# ETHERNOVIA

Improvements to IEEE 802.1CB-2017  
Maintenance Item 0343

IEEE Contribution

**Figure 6-y**—Internal LAN: array of upper SAPs

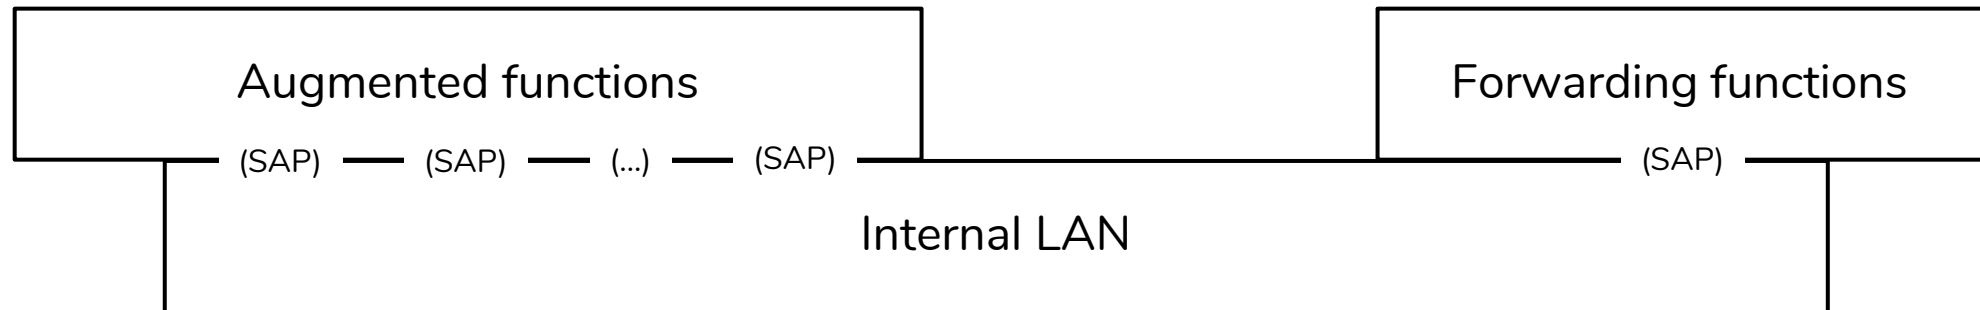
Add new section, text, and figure:

“The Internal LAN models a fully transparent frame transfer function along with all (Enhanced) Internal Sublayer Service (E/ISS) parameters.”

“The Forwarding functions entail the functionality of [Q] sections 8.6.1 through 8.6.5, but not [Q] Clause 6, [Q] section 8.5, nor [Q] sections 8.6.6 through 8.6.8, as those are modelled in the MAC (see Figure 6-6).”

Delete Figure 6-3

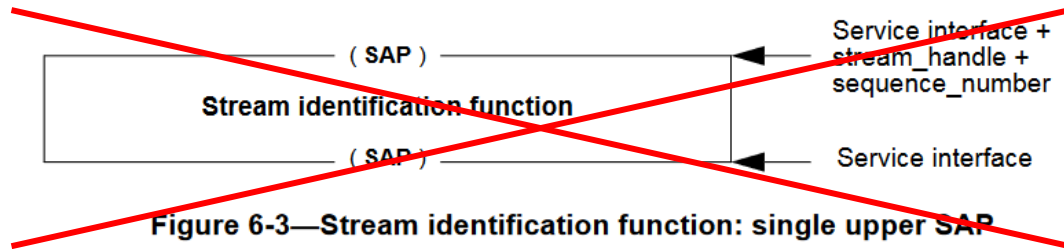
3. Figures 6-5, 6-6, and 8-1 show a Lower and an Upper Stream identification function: “The Lower Stream identification functions separate FRER packets from non-FRER packets; the latter are relayed across the NSTF as if the FRER capabilities were not present. The Upper Stream identification functions identify the FRER packets’ Streams ...” (6.3), while Figure 6-4 shows a single identification block with upper layer SAPs for the different stream\_handles and the NSTF (“Packets belonging to no Stream, or to a Stream unknown to this Stream identification function”).  
The task to “**separate FRER packets from non-FRER packets**” (6.3) is impossible to achieve, as only the match to a Stream Identification function constitutes the Frame to have to be processed by further FRER functionality up the stack.  
The “Lower/Upper Stream identification function” terminology should be removed from 6.3 and Figure 6-3 deleted.

Figure 6-5 b.—Relay system with separated FRER capability, e.g., packet counting, on an output port.

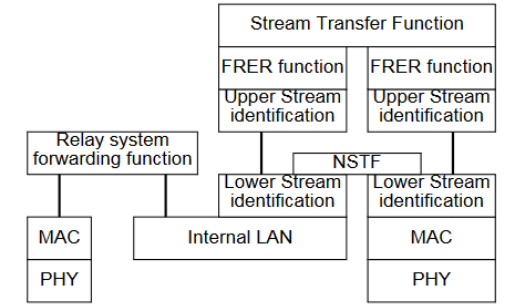
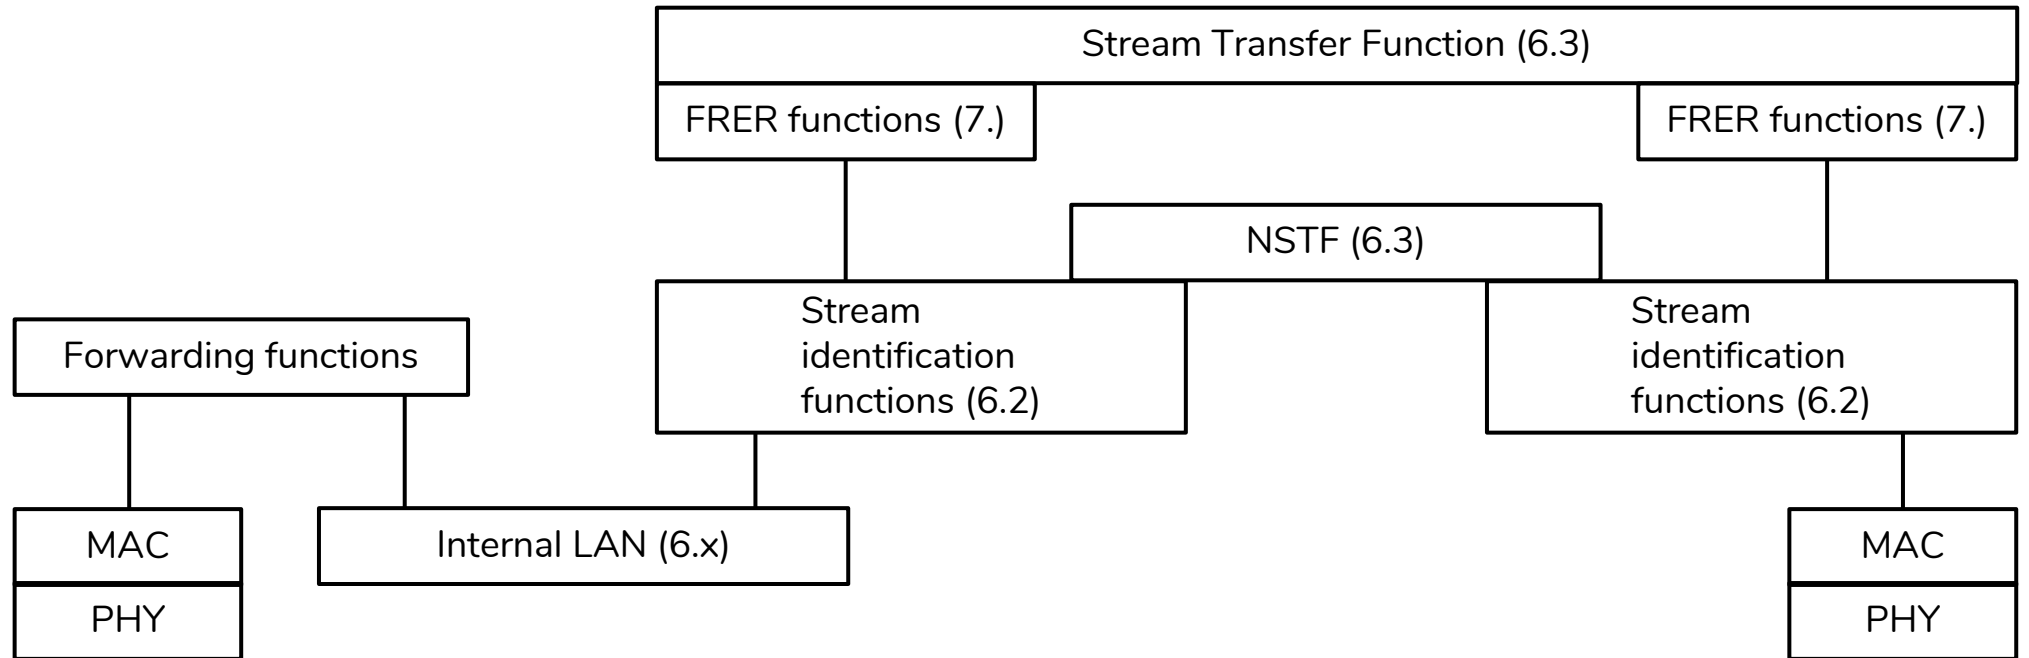
2. Section 8.1 j) “... take place after all forwarding (**except Queuing frames, 8.6.6** of IEEE Std 802.1Q-2014)” and Figure 8-2 contradict Figures 6-5, 6-6, 8-1, C-5, C-6, C-7, and C-12, as the later all show or imply ALL functionality of [Q]:8.6 to be encompassed by the “(Relay system) Forwarding function”.  
Since 8.1 j) and Figure 8-2 have been determined to be correct, the other figures need to be adapted accordingly.

# Modify Figure 6-5 b.

Figure 6-6—In- and out-facing functions

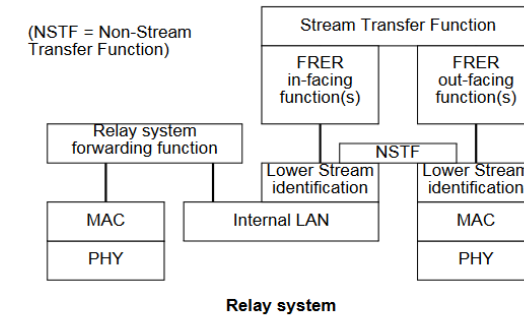
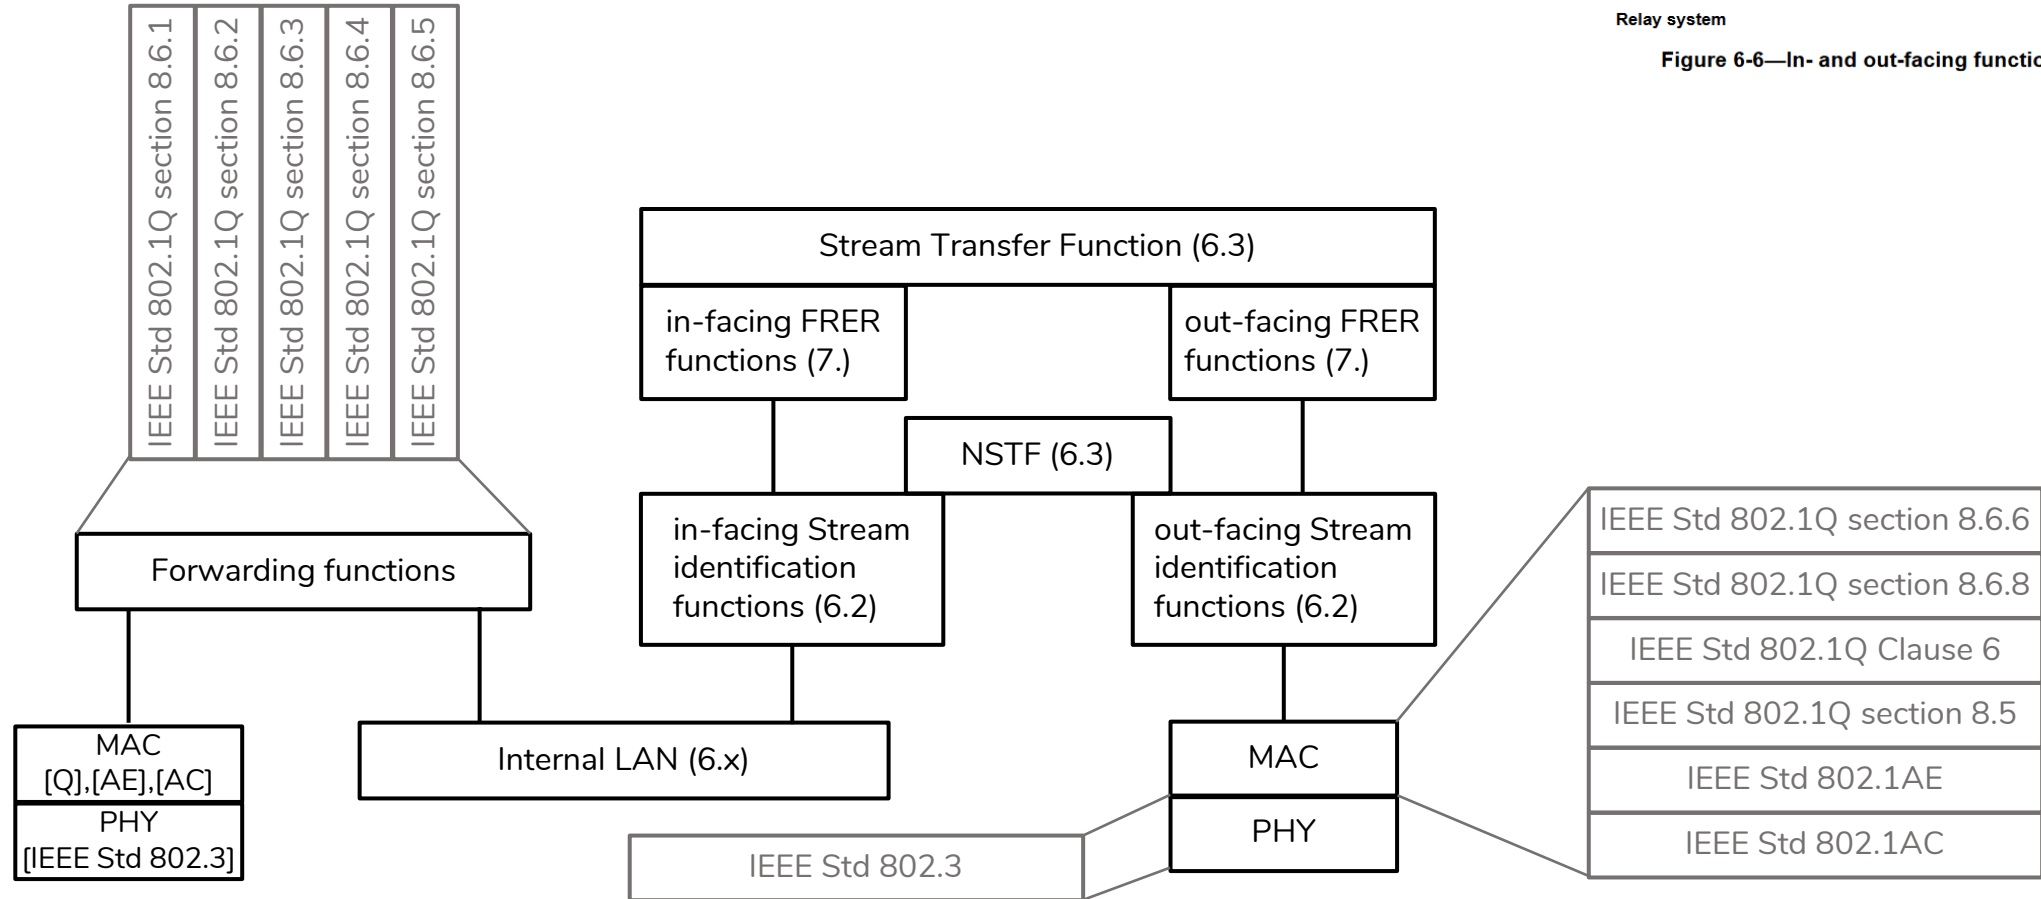
# Modify Figure 6-6

Figure 8-1—Relay system split

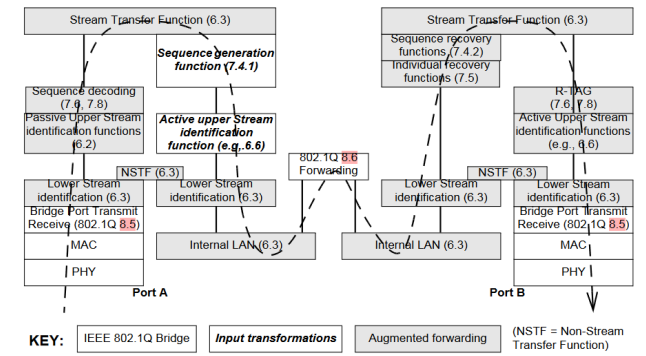
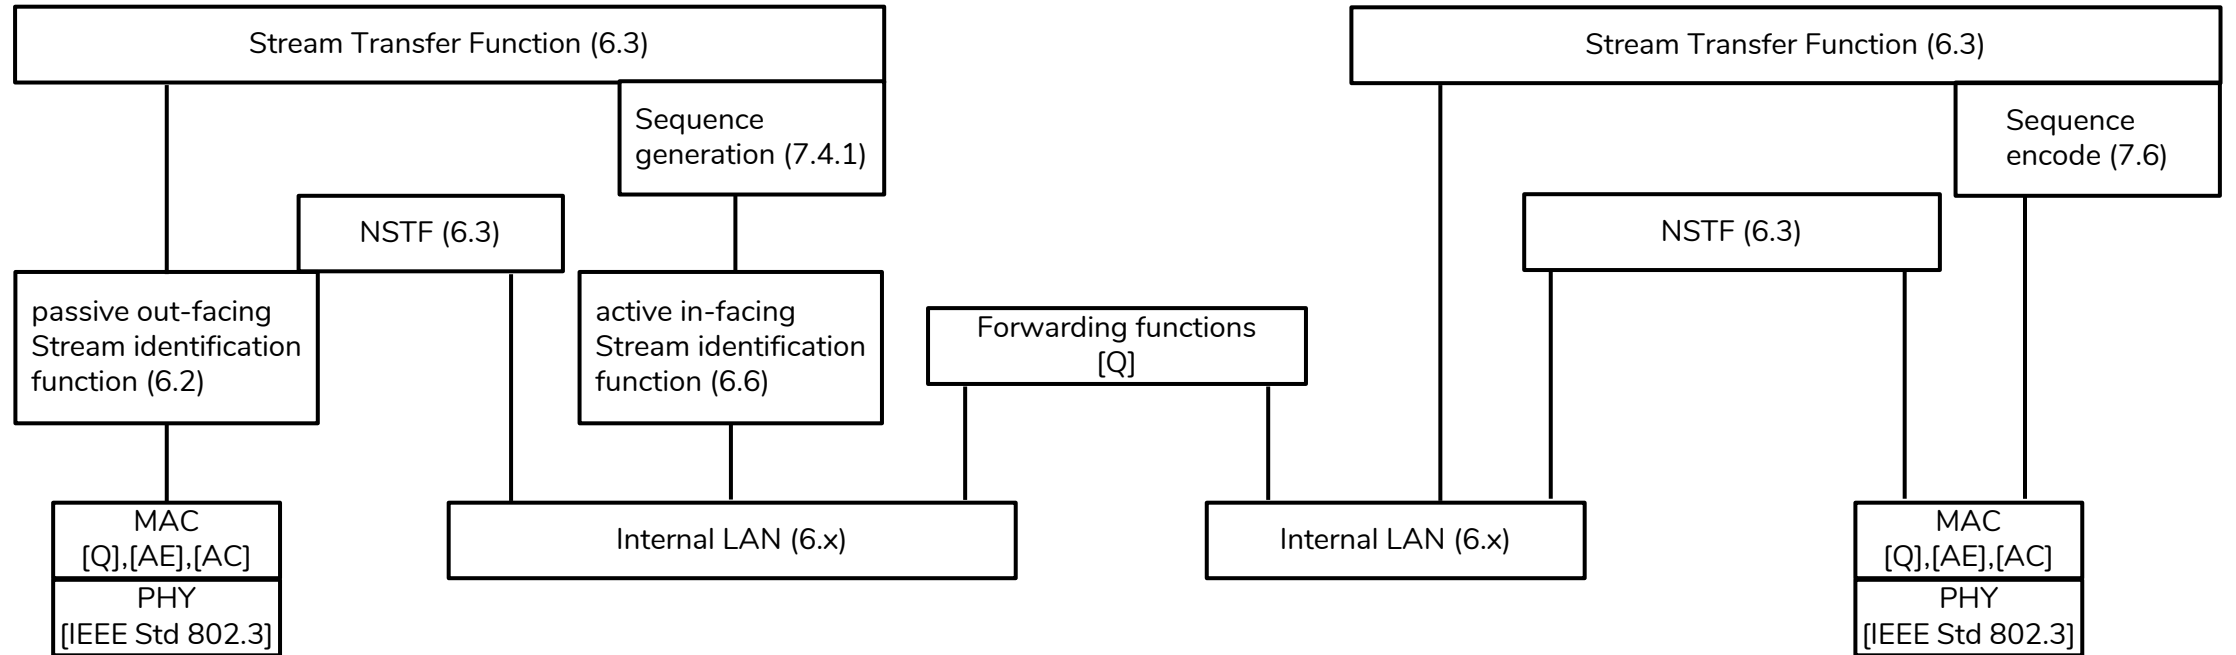
# Modify Figure 8-1 part I

Figure 8-1—Relay system recover

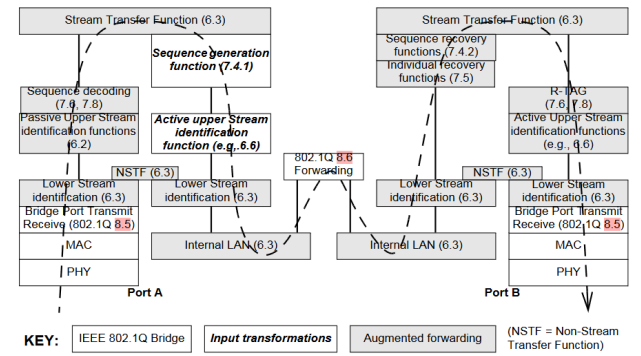
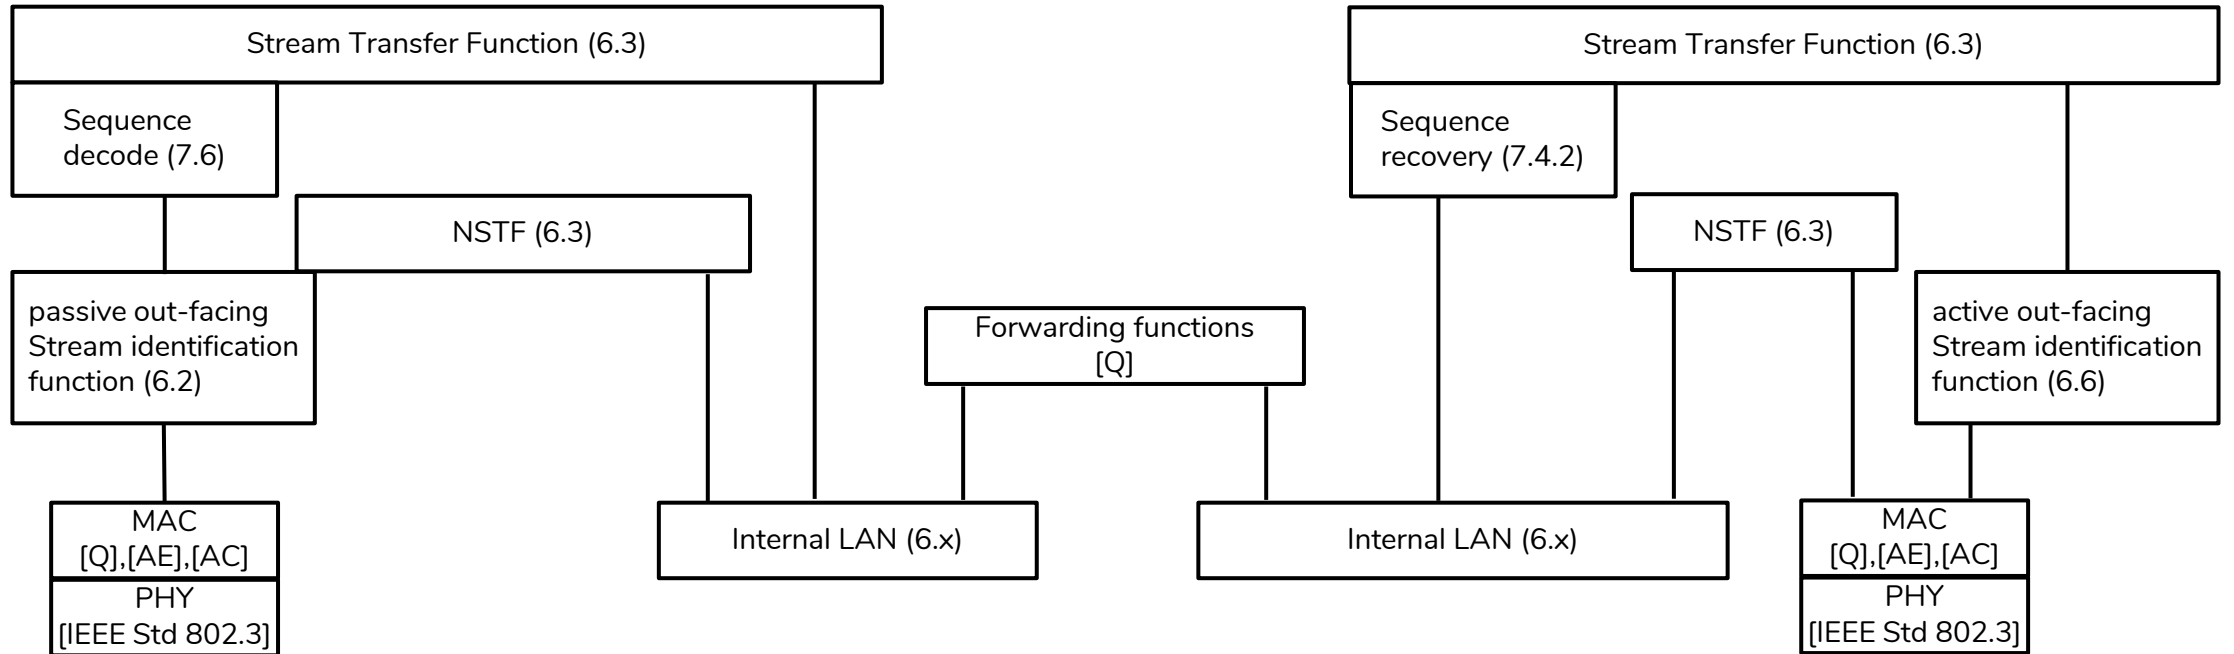
# Modify Figure 8-1 part II

Figure C-5—Protocol stack for relay system B, proxying for End System A, in Figure C-4

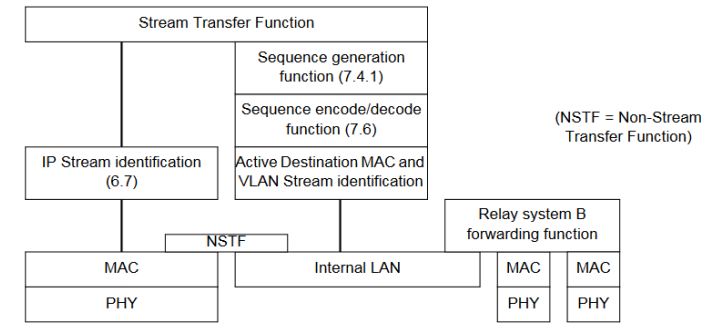
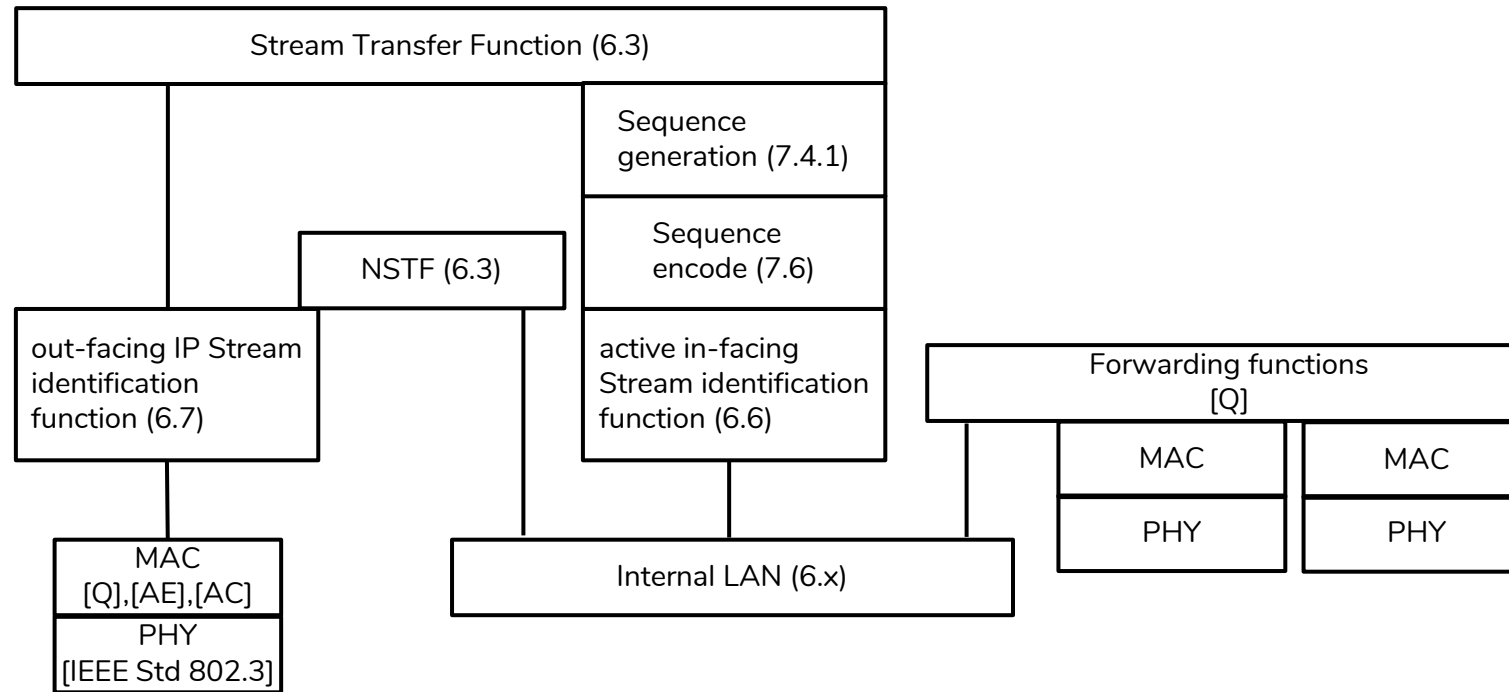
# Modify Figure C-5

Figure C-6—Protocol stack for relay system C in Figure C-4

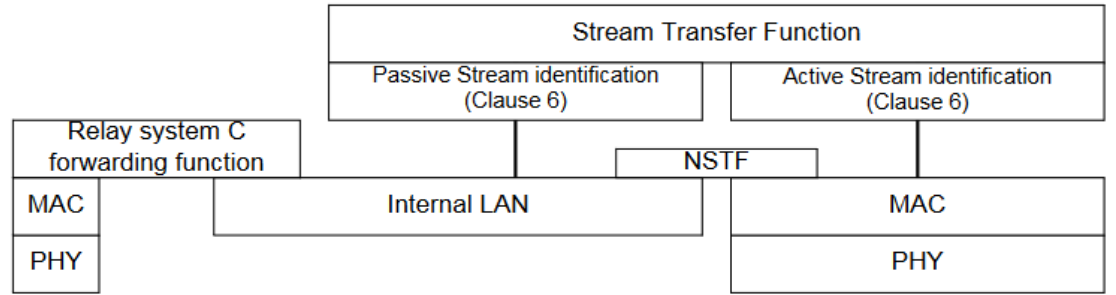
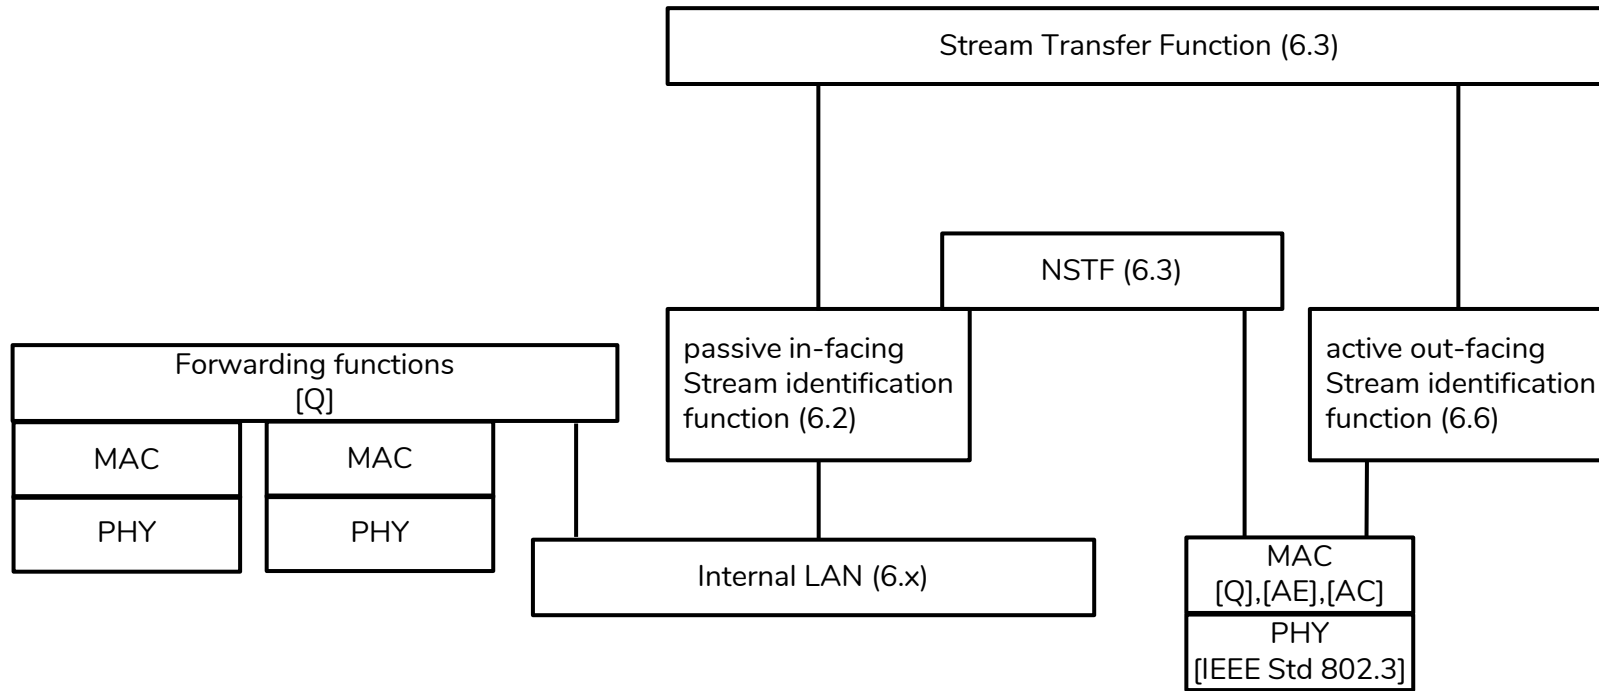
# Modify Figure C-6
